MINERALS PROGRAM INSPECTION REPORT

MINE NAME: Jenkins Site	MINE/PROSPECTING ID#: M-1977-393	MINERAL: Sand and gravel	COUNTY: Boulder
INSPECTION TYPE: Monitoring	INSPECTOR(S): Amy Eschberger	INSP. DATE: October 29, 2020	INSP. TIME: 09:00
OPERATOR: City of Boulder	OPERATOR REPRESENTATIVE: Chris Lawlor	TYPE OF OPERATION: 112c - Construction Regular Operation	
REASON FOR INSPECTION: Normal I&E Program	BOND CALCULATION TYPE: None	BOND AMOUNT: \$0.00	
DATE OF COMPLAINT: NA	POST INSP. CONTACTS: None	JOINT INSP. AGENCY: None	
WEATHER: Clear	INSPECTOR'S SIGNATURE: 	SIGNATURE DATE: November 13, 2020

M-1977-393 / Jenkins Site / City of Boulder (112c Permit)

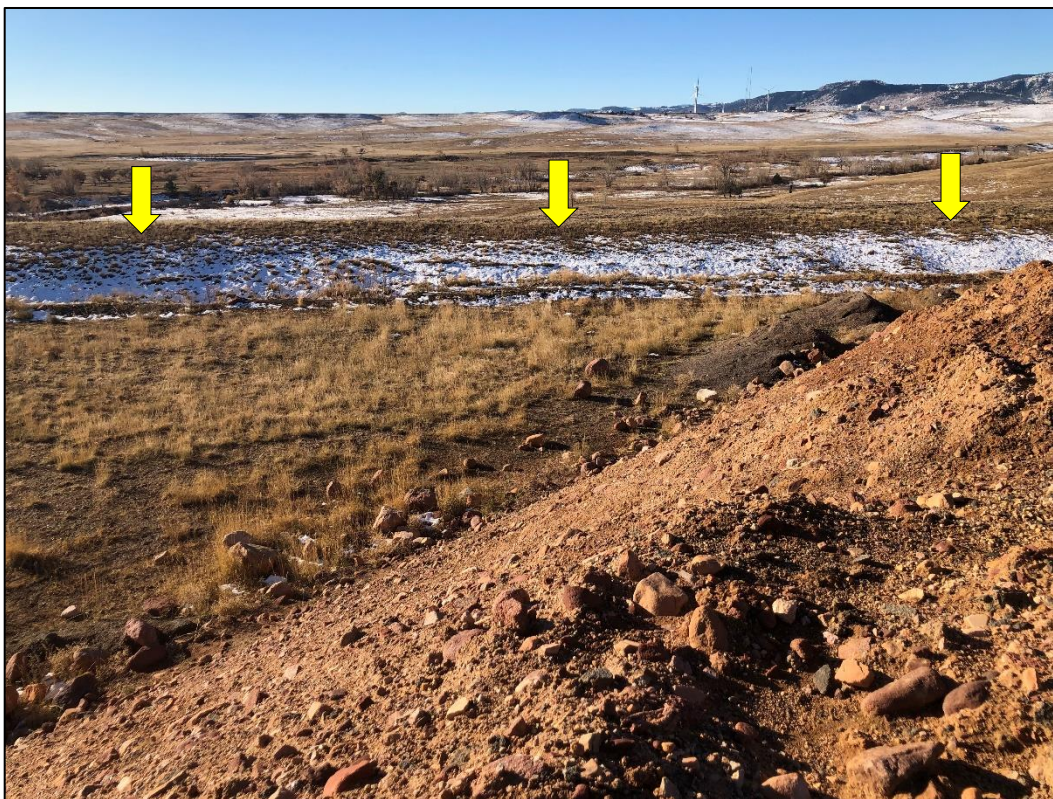
Photo 1. View looking southwest from main access road at eastern edge of lower lift (indicated) placed inside pit in north mining area.

Photo 2. Closer view of eastern edge of lower lift placed inside pit in north mining area. Side slopes of this lift are at ~1.5H:1V.

Photo 3. View looking east across top of lower lift placed inside pit in north mining area.

Photo 4. View looking southeast across top of lower lift placed inside pit in north mining area.

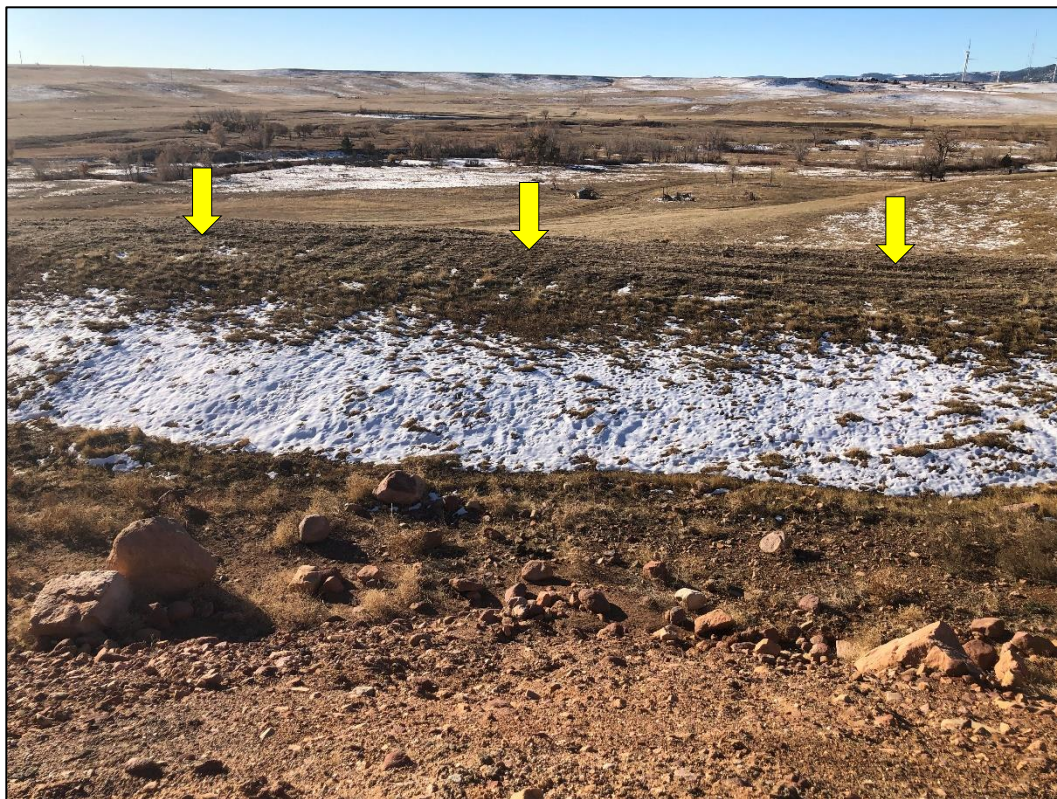
Photo 5. View looking south across top of lower lift placed inside pit in north mining area. Note side slope of upper lift (in foreground) at ~1.5H:1V. Also note southern rim of pit (indicated in background).

Photo 6. View looking northeast at boulders stockpiled at eastern edge of upper lift.

Photo 7. View looking northeast showing haul truck dumping additional boulders at eastern edge of upper lift during inspection.

Photo 8. View looking west at small stockpiles of imported material stored at southern edge of upper lift.

Photo 9. View looking northeast across top of upper lift placed inside pit in north mining area.

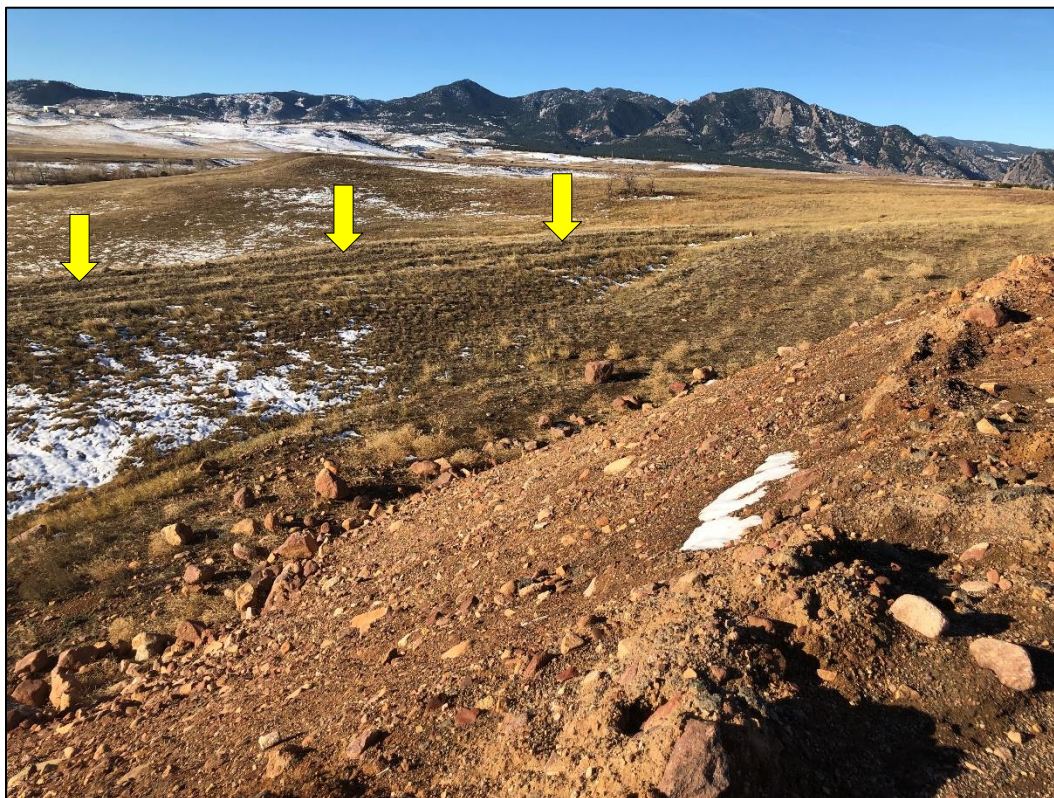
Photo 10. View looking south from top of upper lift placed inside pit in north mining area. Note southern rim of pit (indicated in background).

Photo 11. View looking southeast from top of upper lift placed inside pit in north mining area. Note side slope of upper lift (in foreground) at $\sim 1.5H:1V$. Also note southern rim of pit (indicated in background).

Photo 12. View looking west from top of upper lift placed inside pit in north mining area. Note side slope of upper lift (in foreground) at $\sim 1.5H:1V$. Also note southern rim of pit (indicated in background).

Photo 13. View looking west across reclaimed area located west of pit where cattle were grazing during inspection.

Photo 14. View looking south across permit area from top of upper lift. Coal Creek (lined by trees in background) bisects permit area.

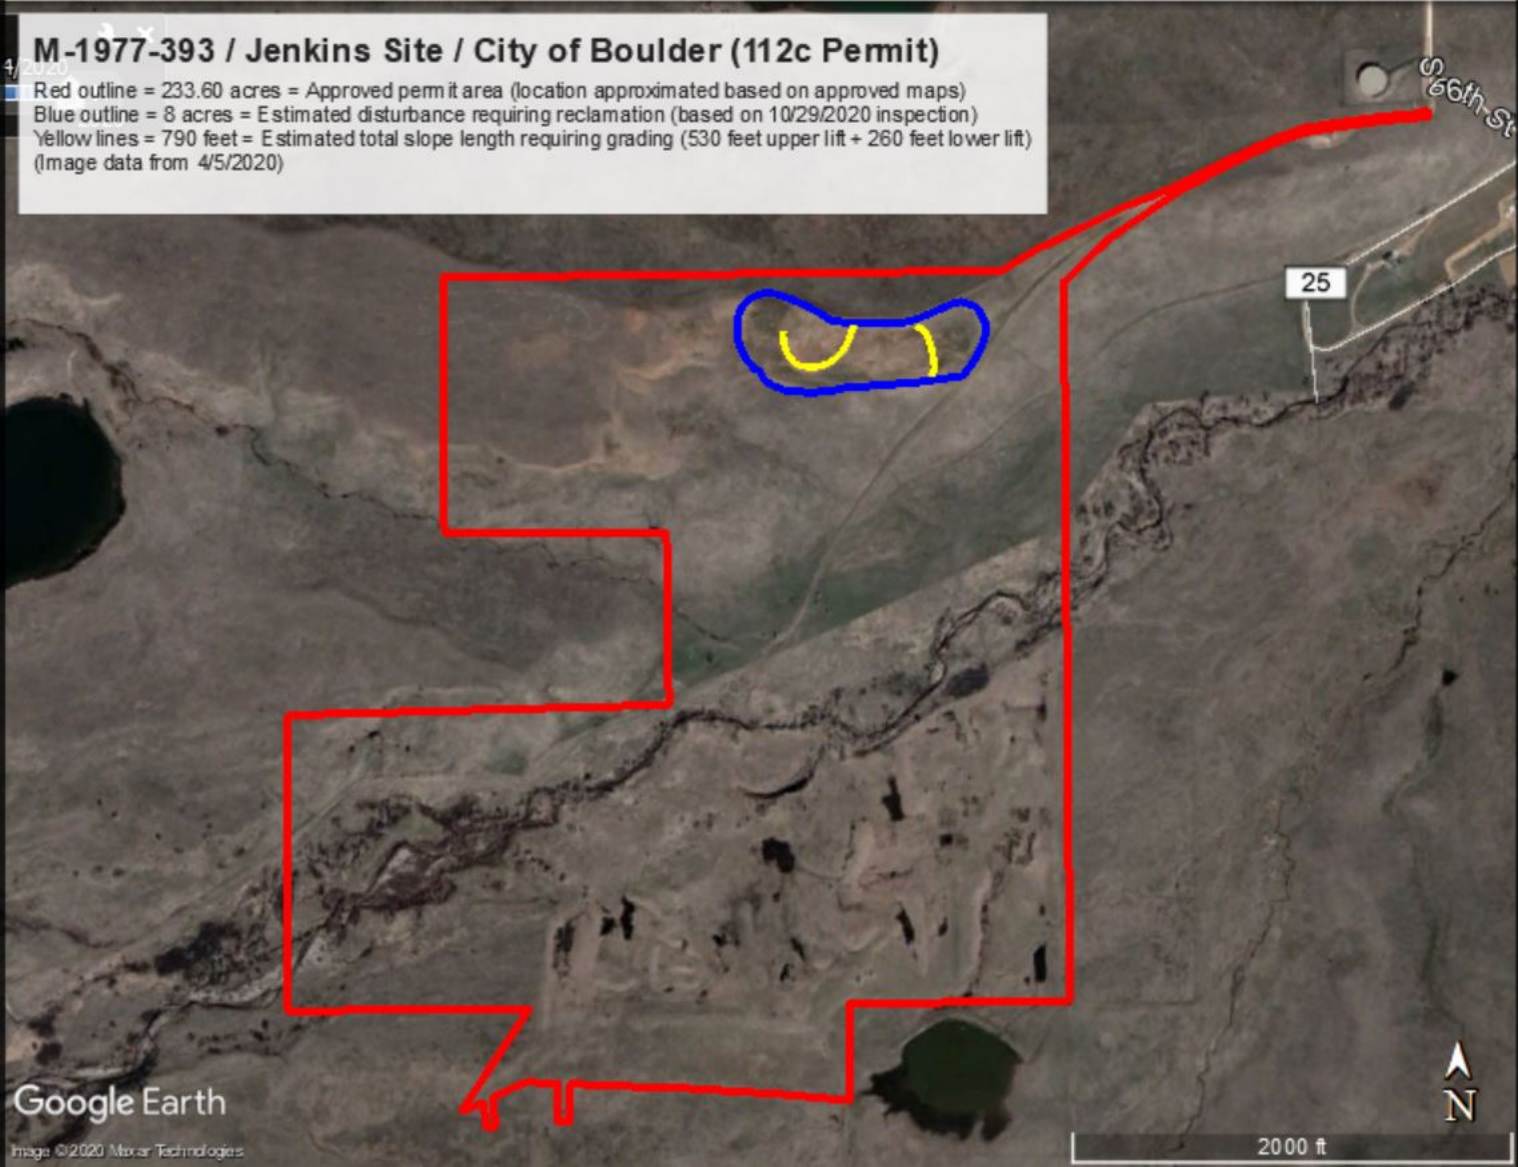
The only portion of the permit area requiring reclamation is the pit area at the top of the mesa in the north mining area (approximately 8 acres in size; see enclosed Google Earth image of site with closer view of disturbed area). The pit is elongated roughly east-west and opens up to the east. The approved reclamation plan

The Division estimates remaining reclamation of the north mining area (in its current condition) to include grading the sides of the backfill lifts to 3H:1V or flatter (approximately 530 feet for the upper lift and approximately 260 feet for the lower lift), replacing 6-10 inches of growth medium on approximately 8 acres, and revegetating the land with the approved rangeland grass mixture. Considering the area is currently used for livestock grazing (cattle were seen grazing just west of the pit during the inspection), the operator will most likely need to install fencing to protect areas undergoing revegetation from livestock disturbance.

Red outline = 233.60 acres = Approved permit area (location approximated based on approved maps)
Blue outline = 8 acres = Estimated disturbance requiring reclamation (based on 10/29/2020 inspection)
Yellow lines = 790 feet = Estimated total slope length requiring grading (530 feet upper lift + 260 feet lower lift)
(Image data from 4/5/2020)
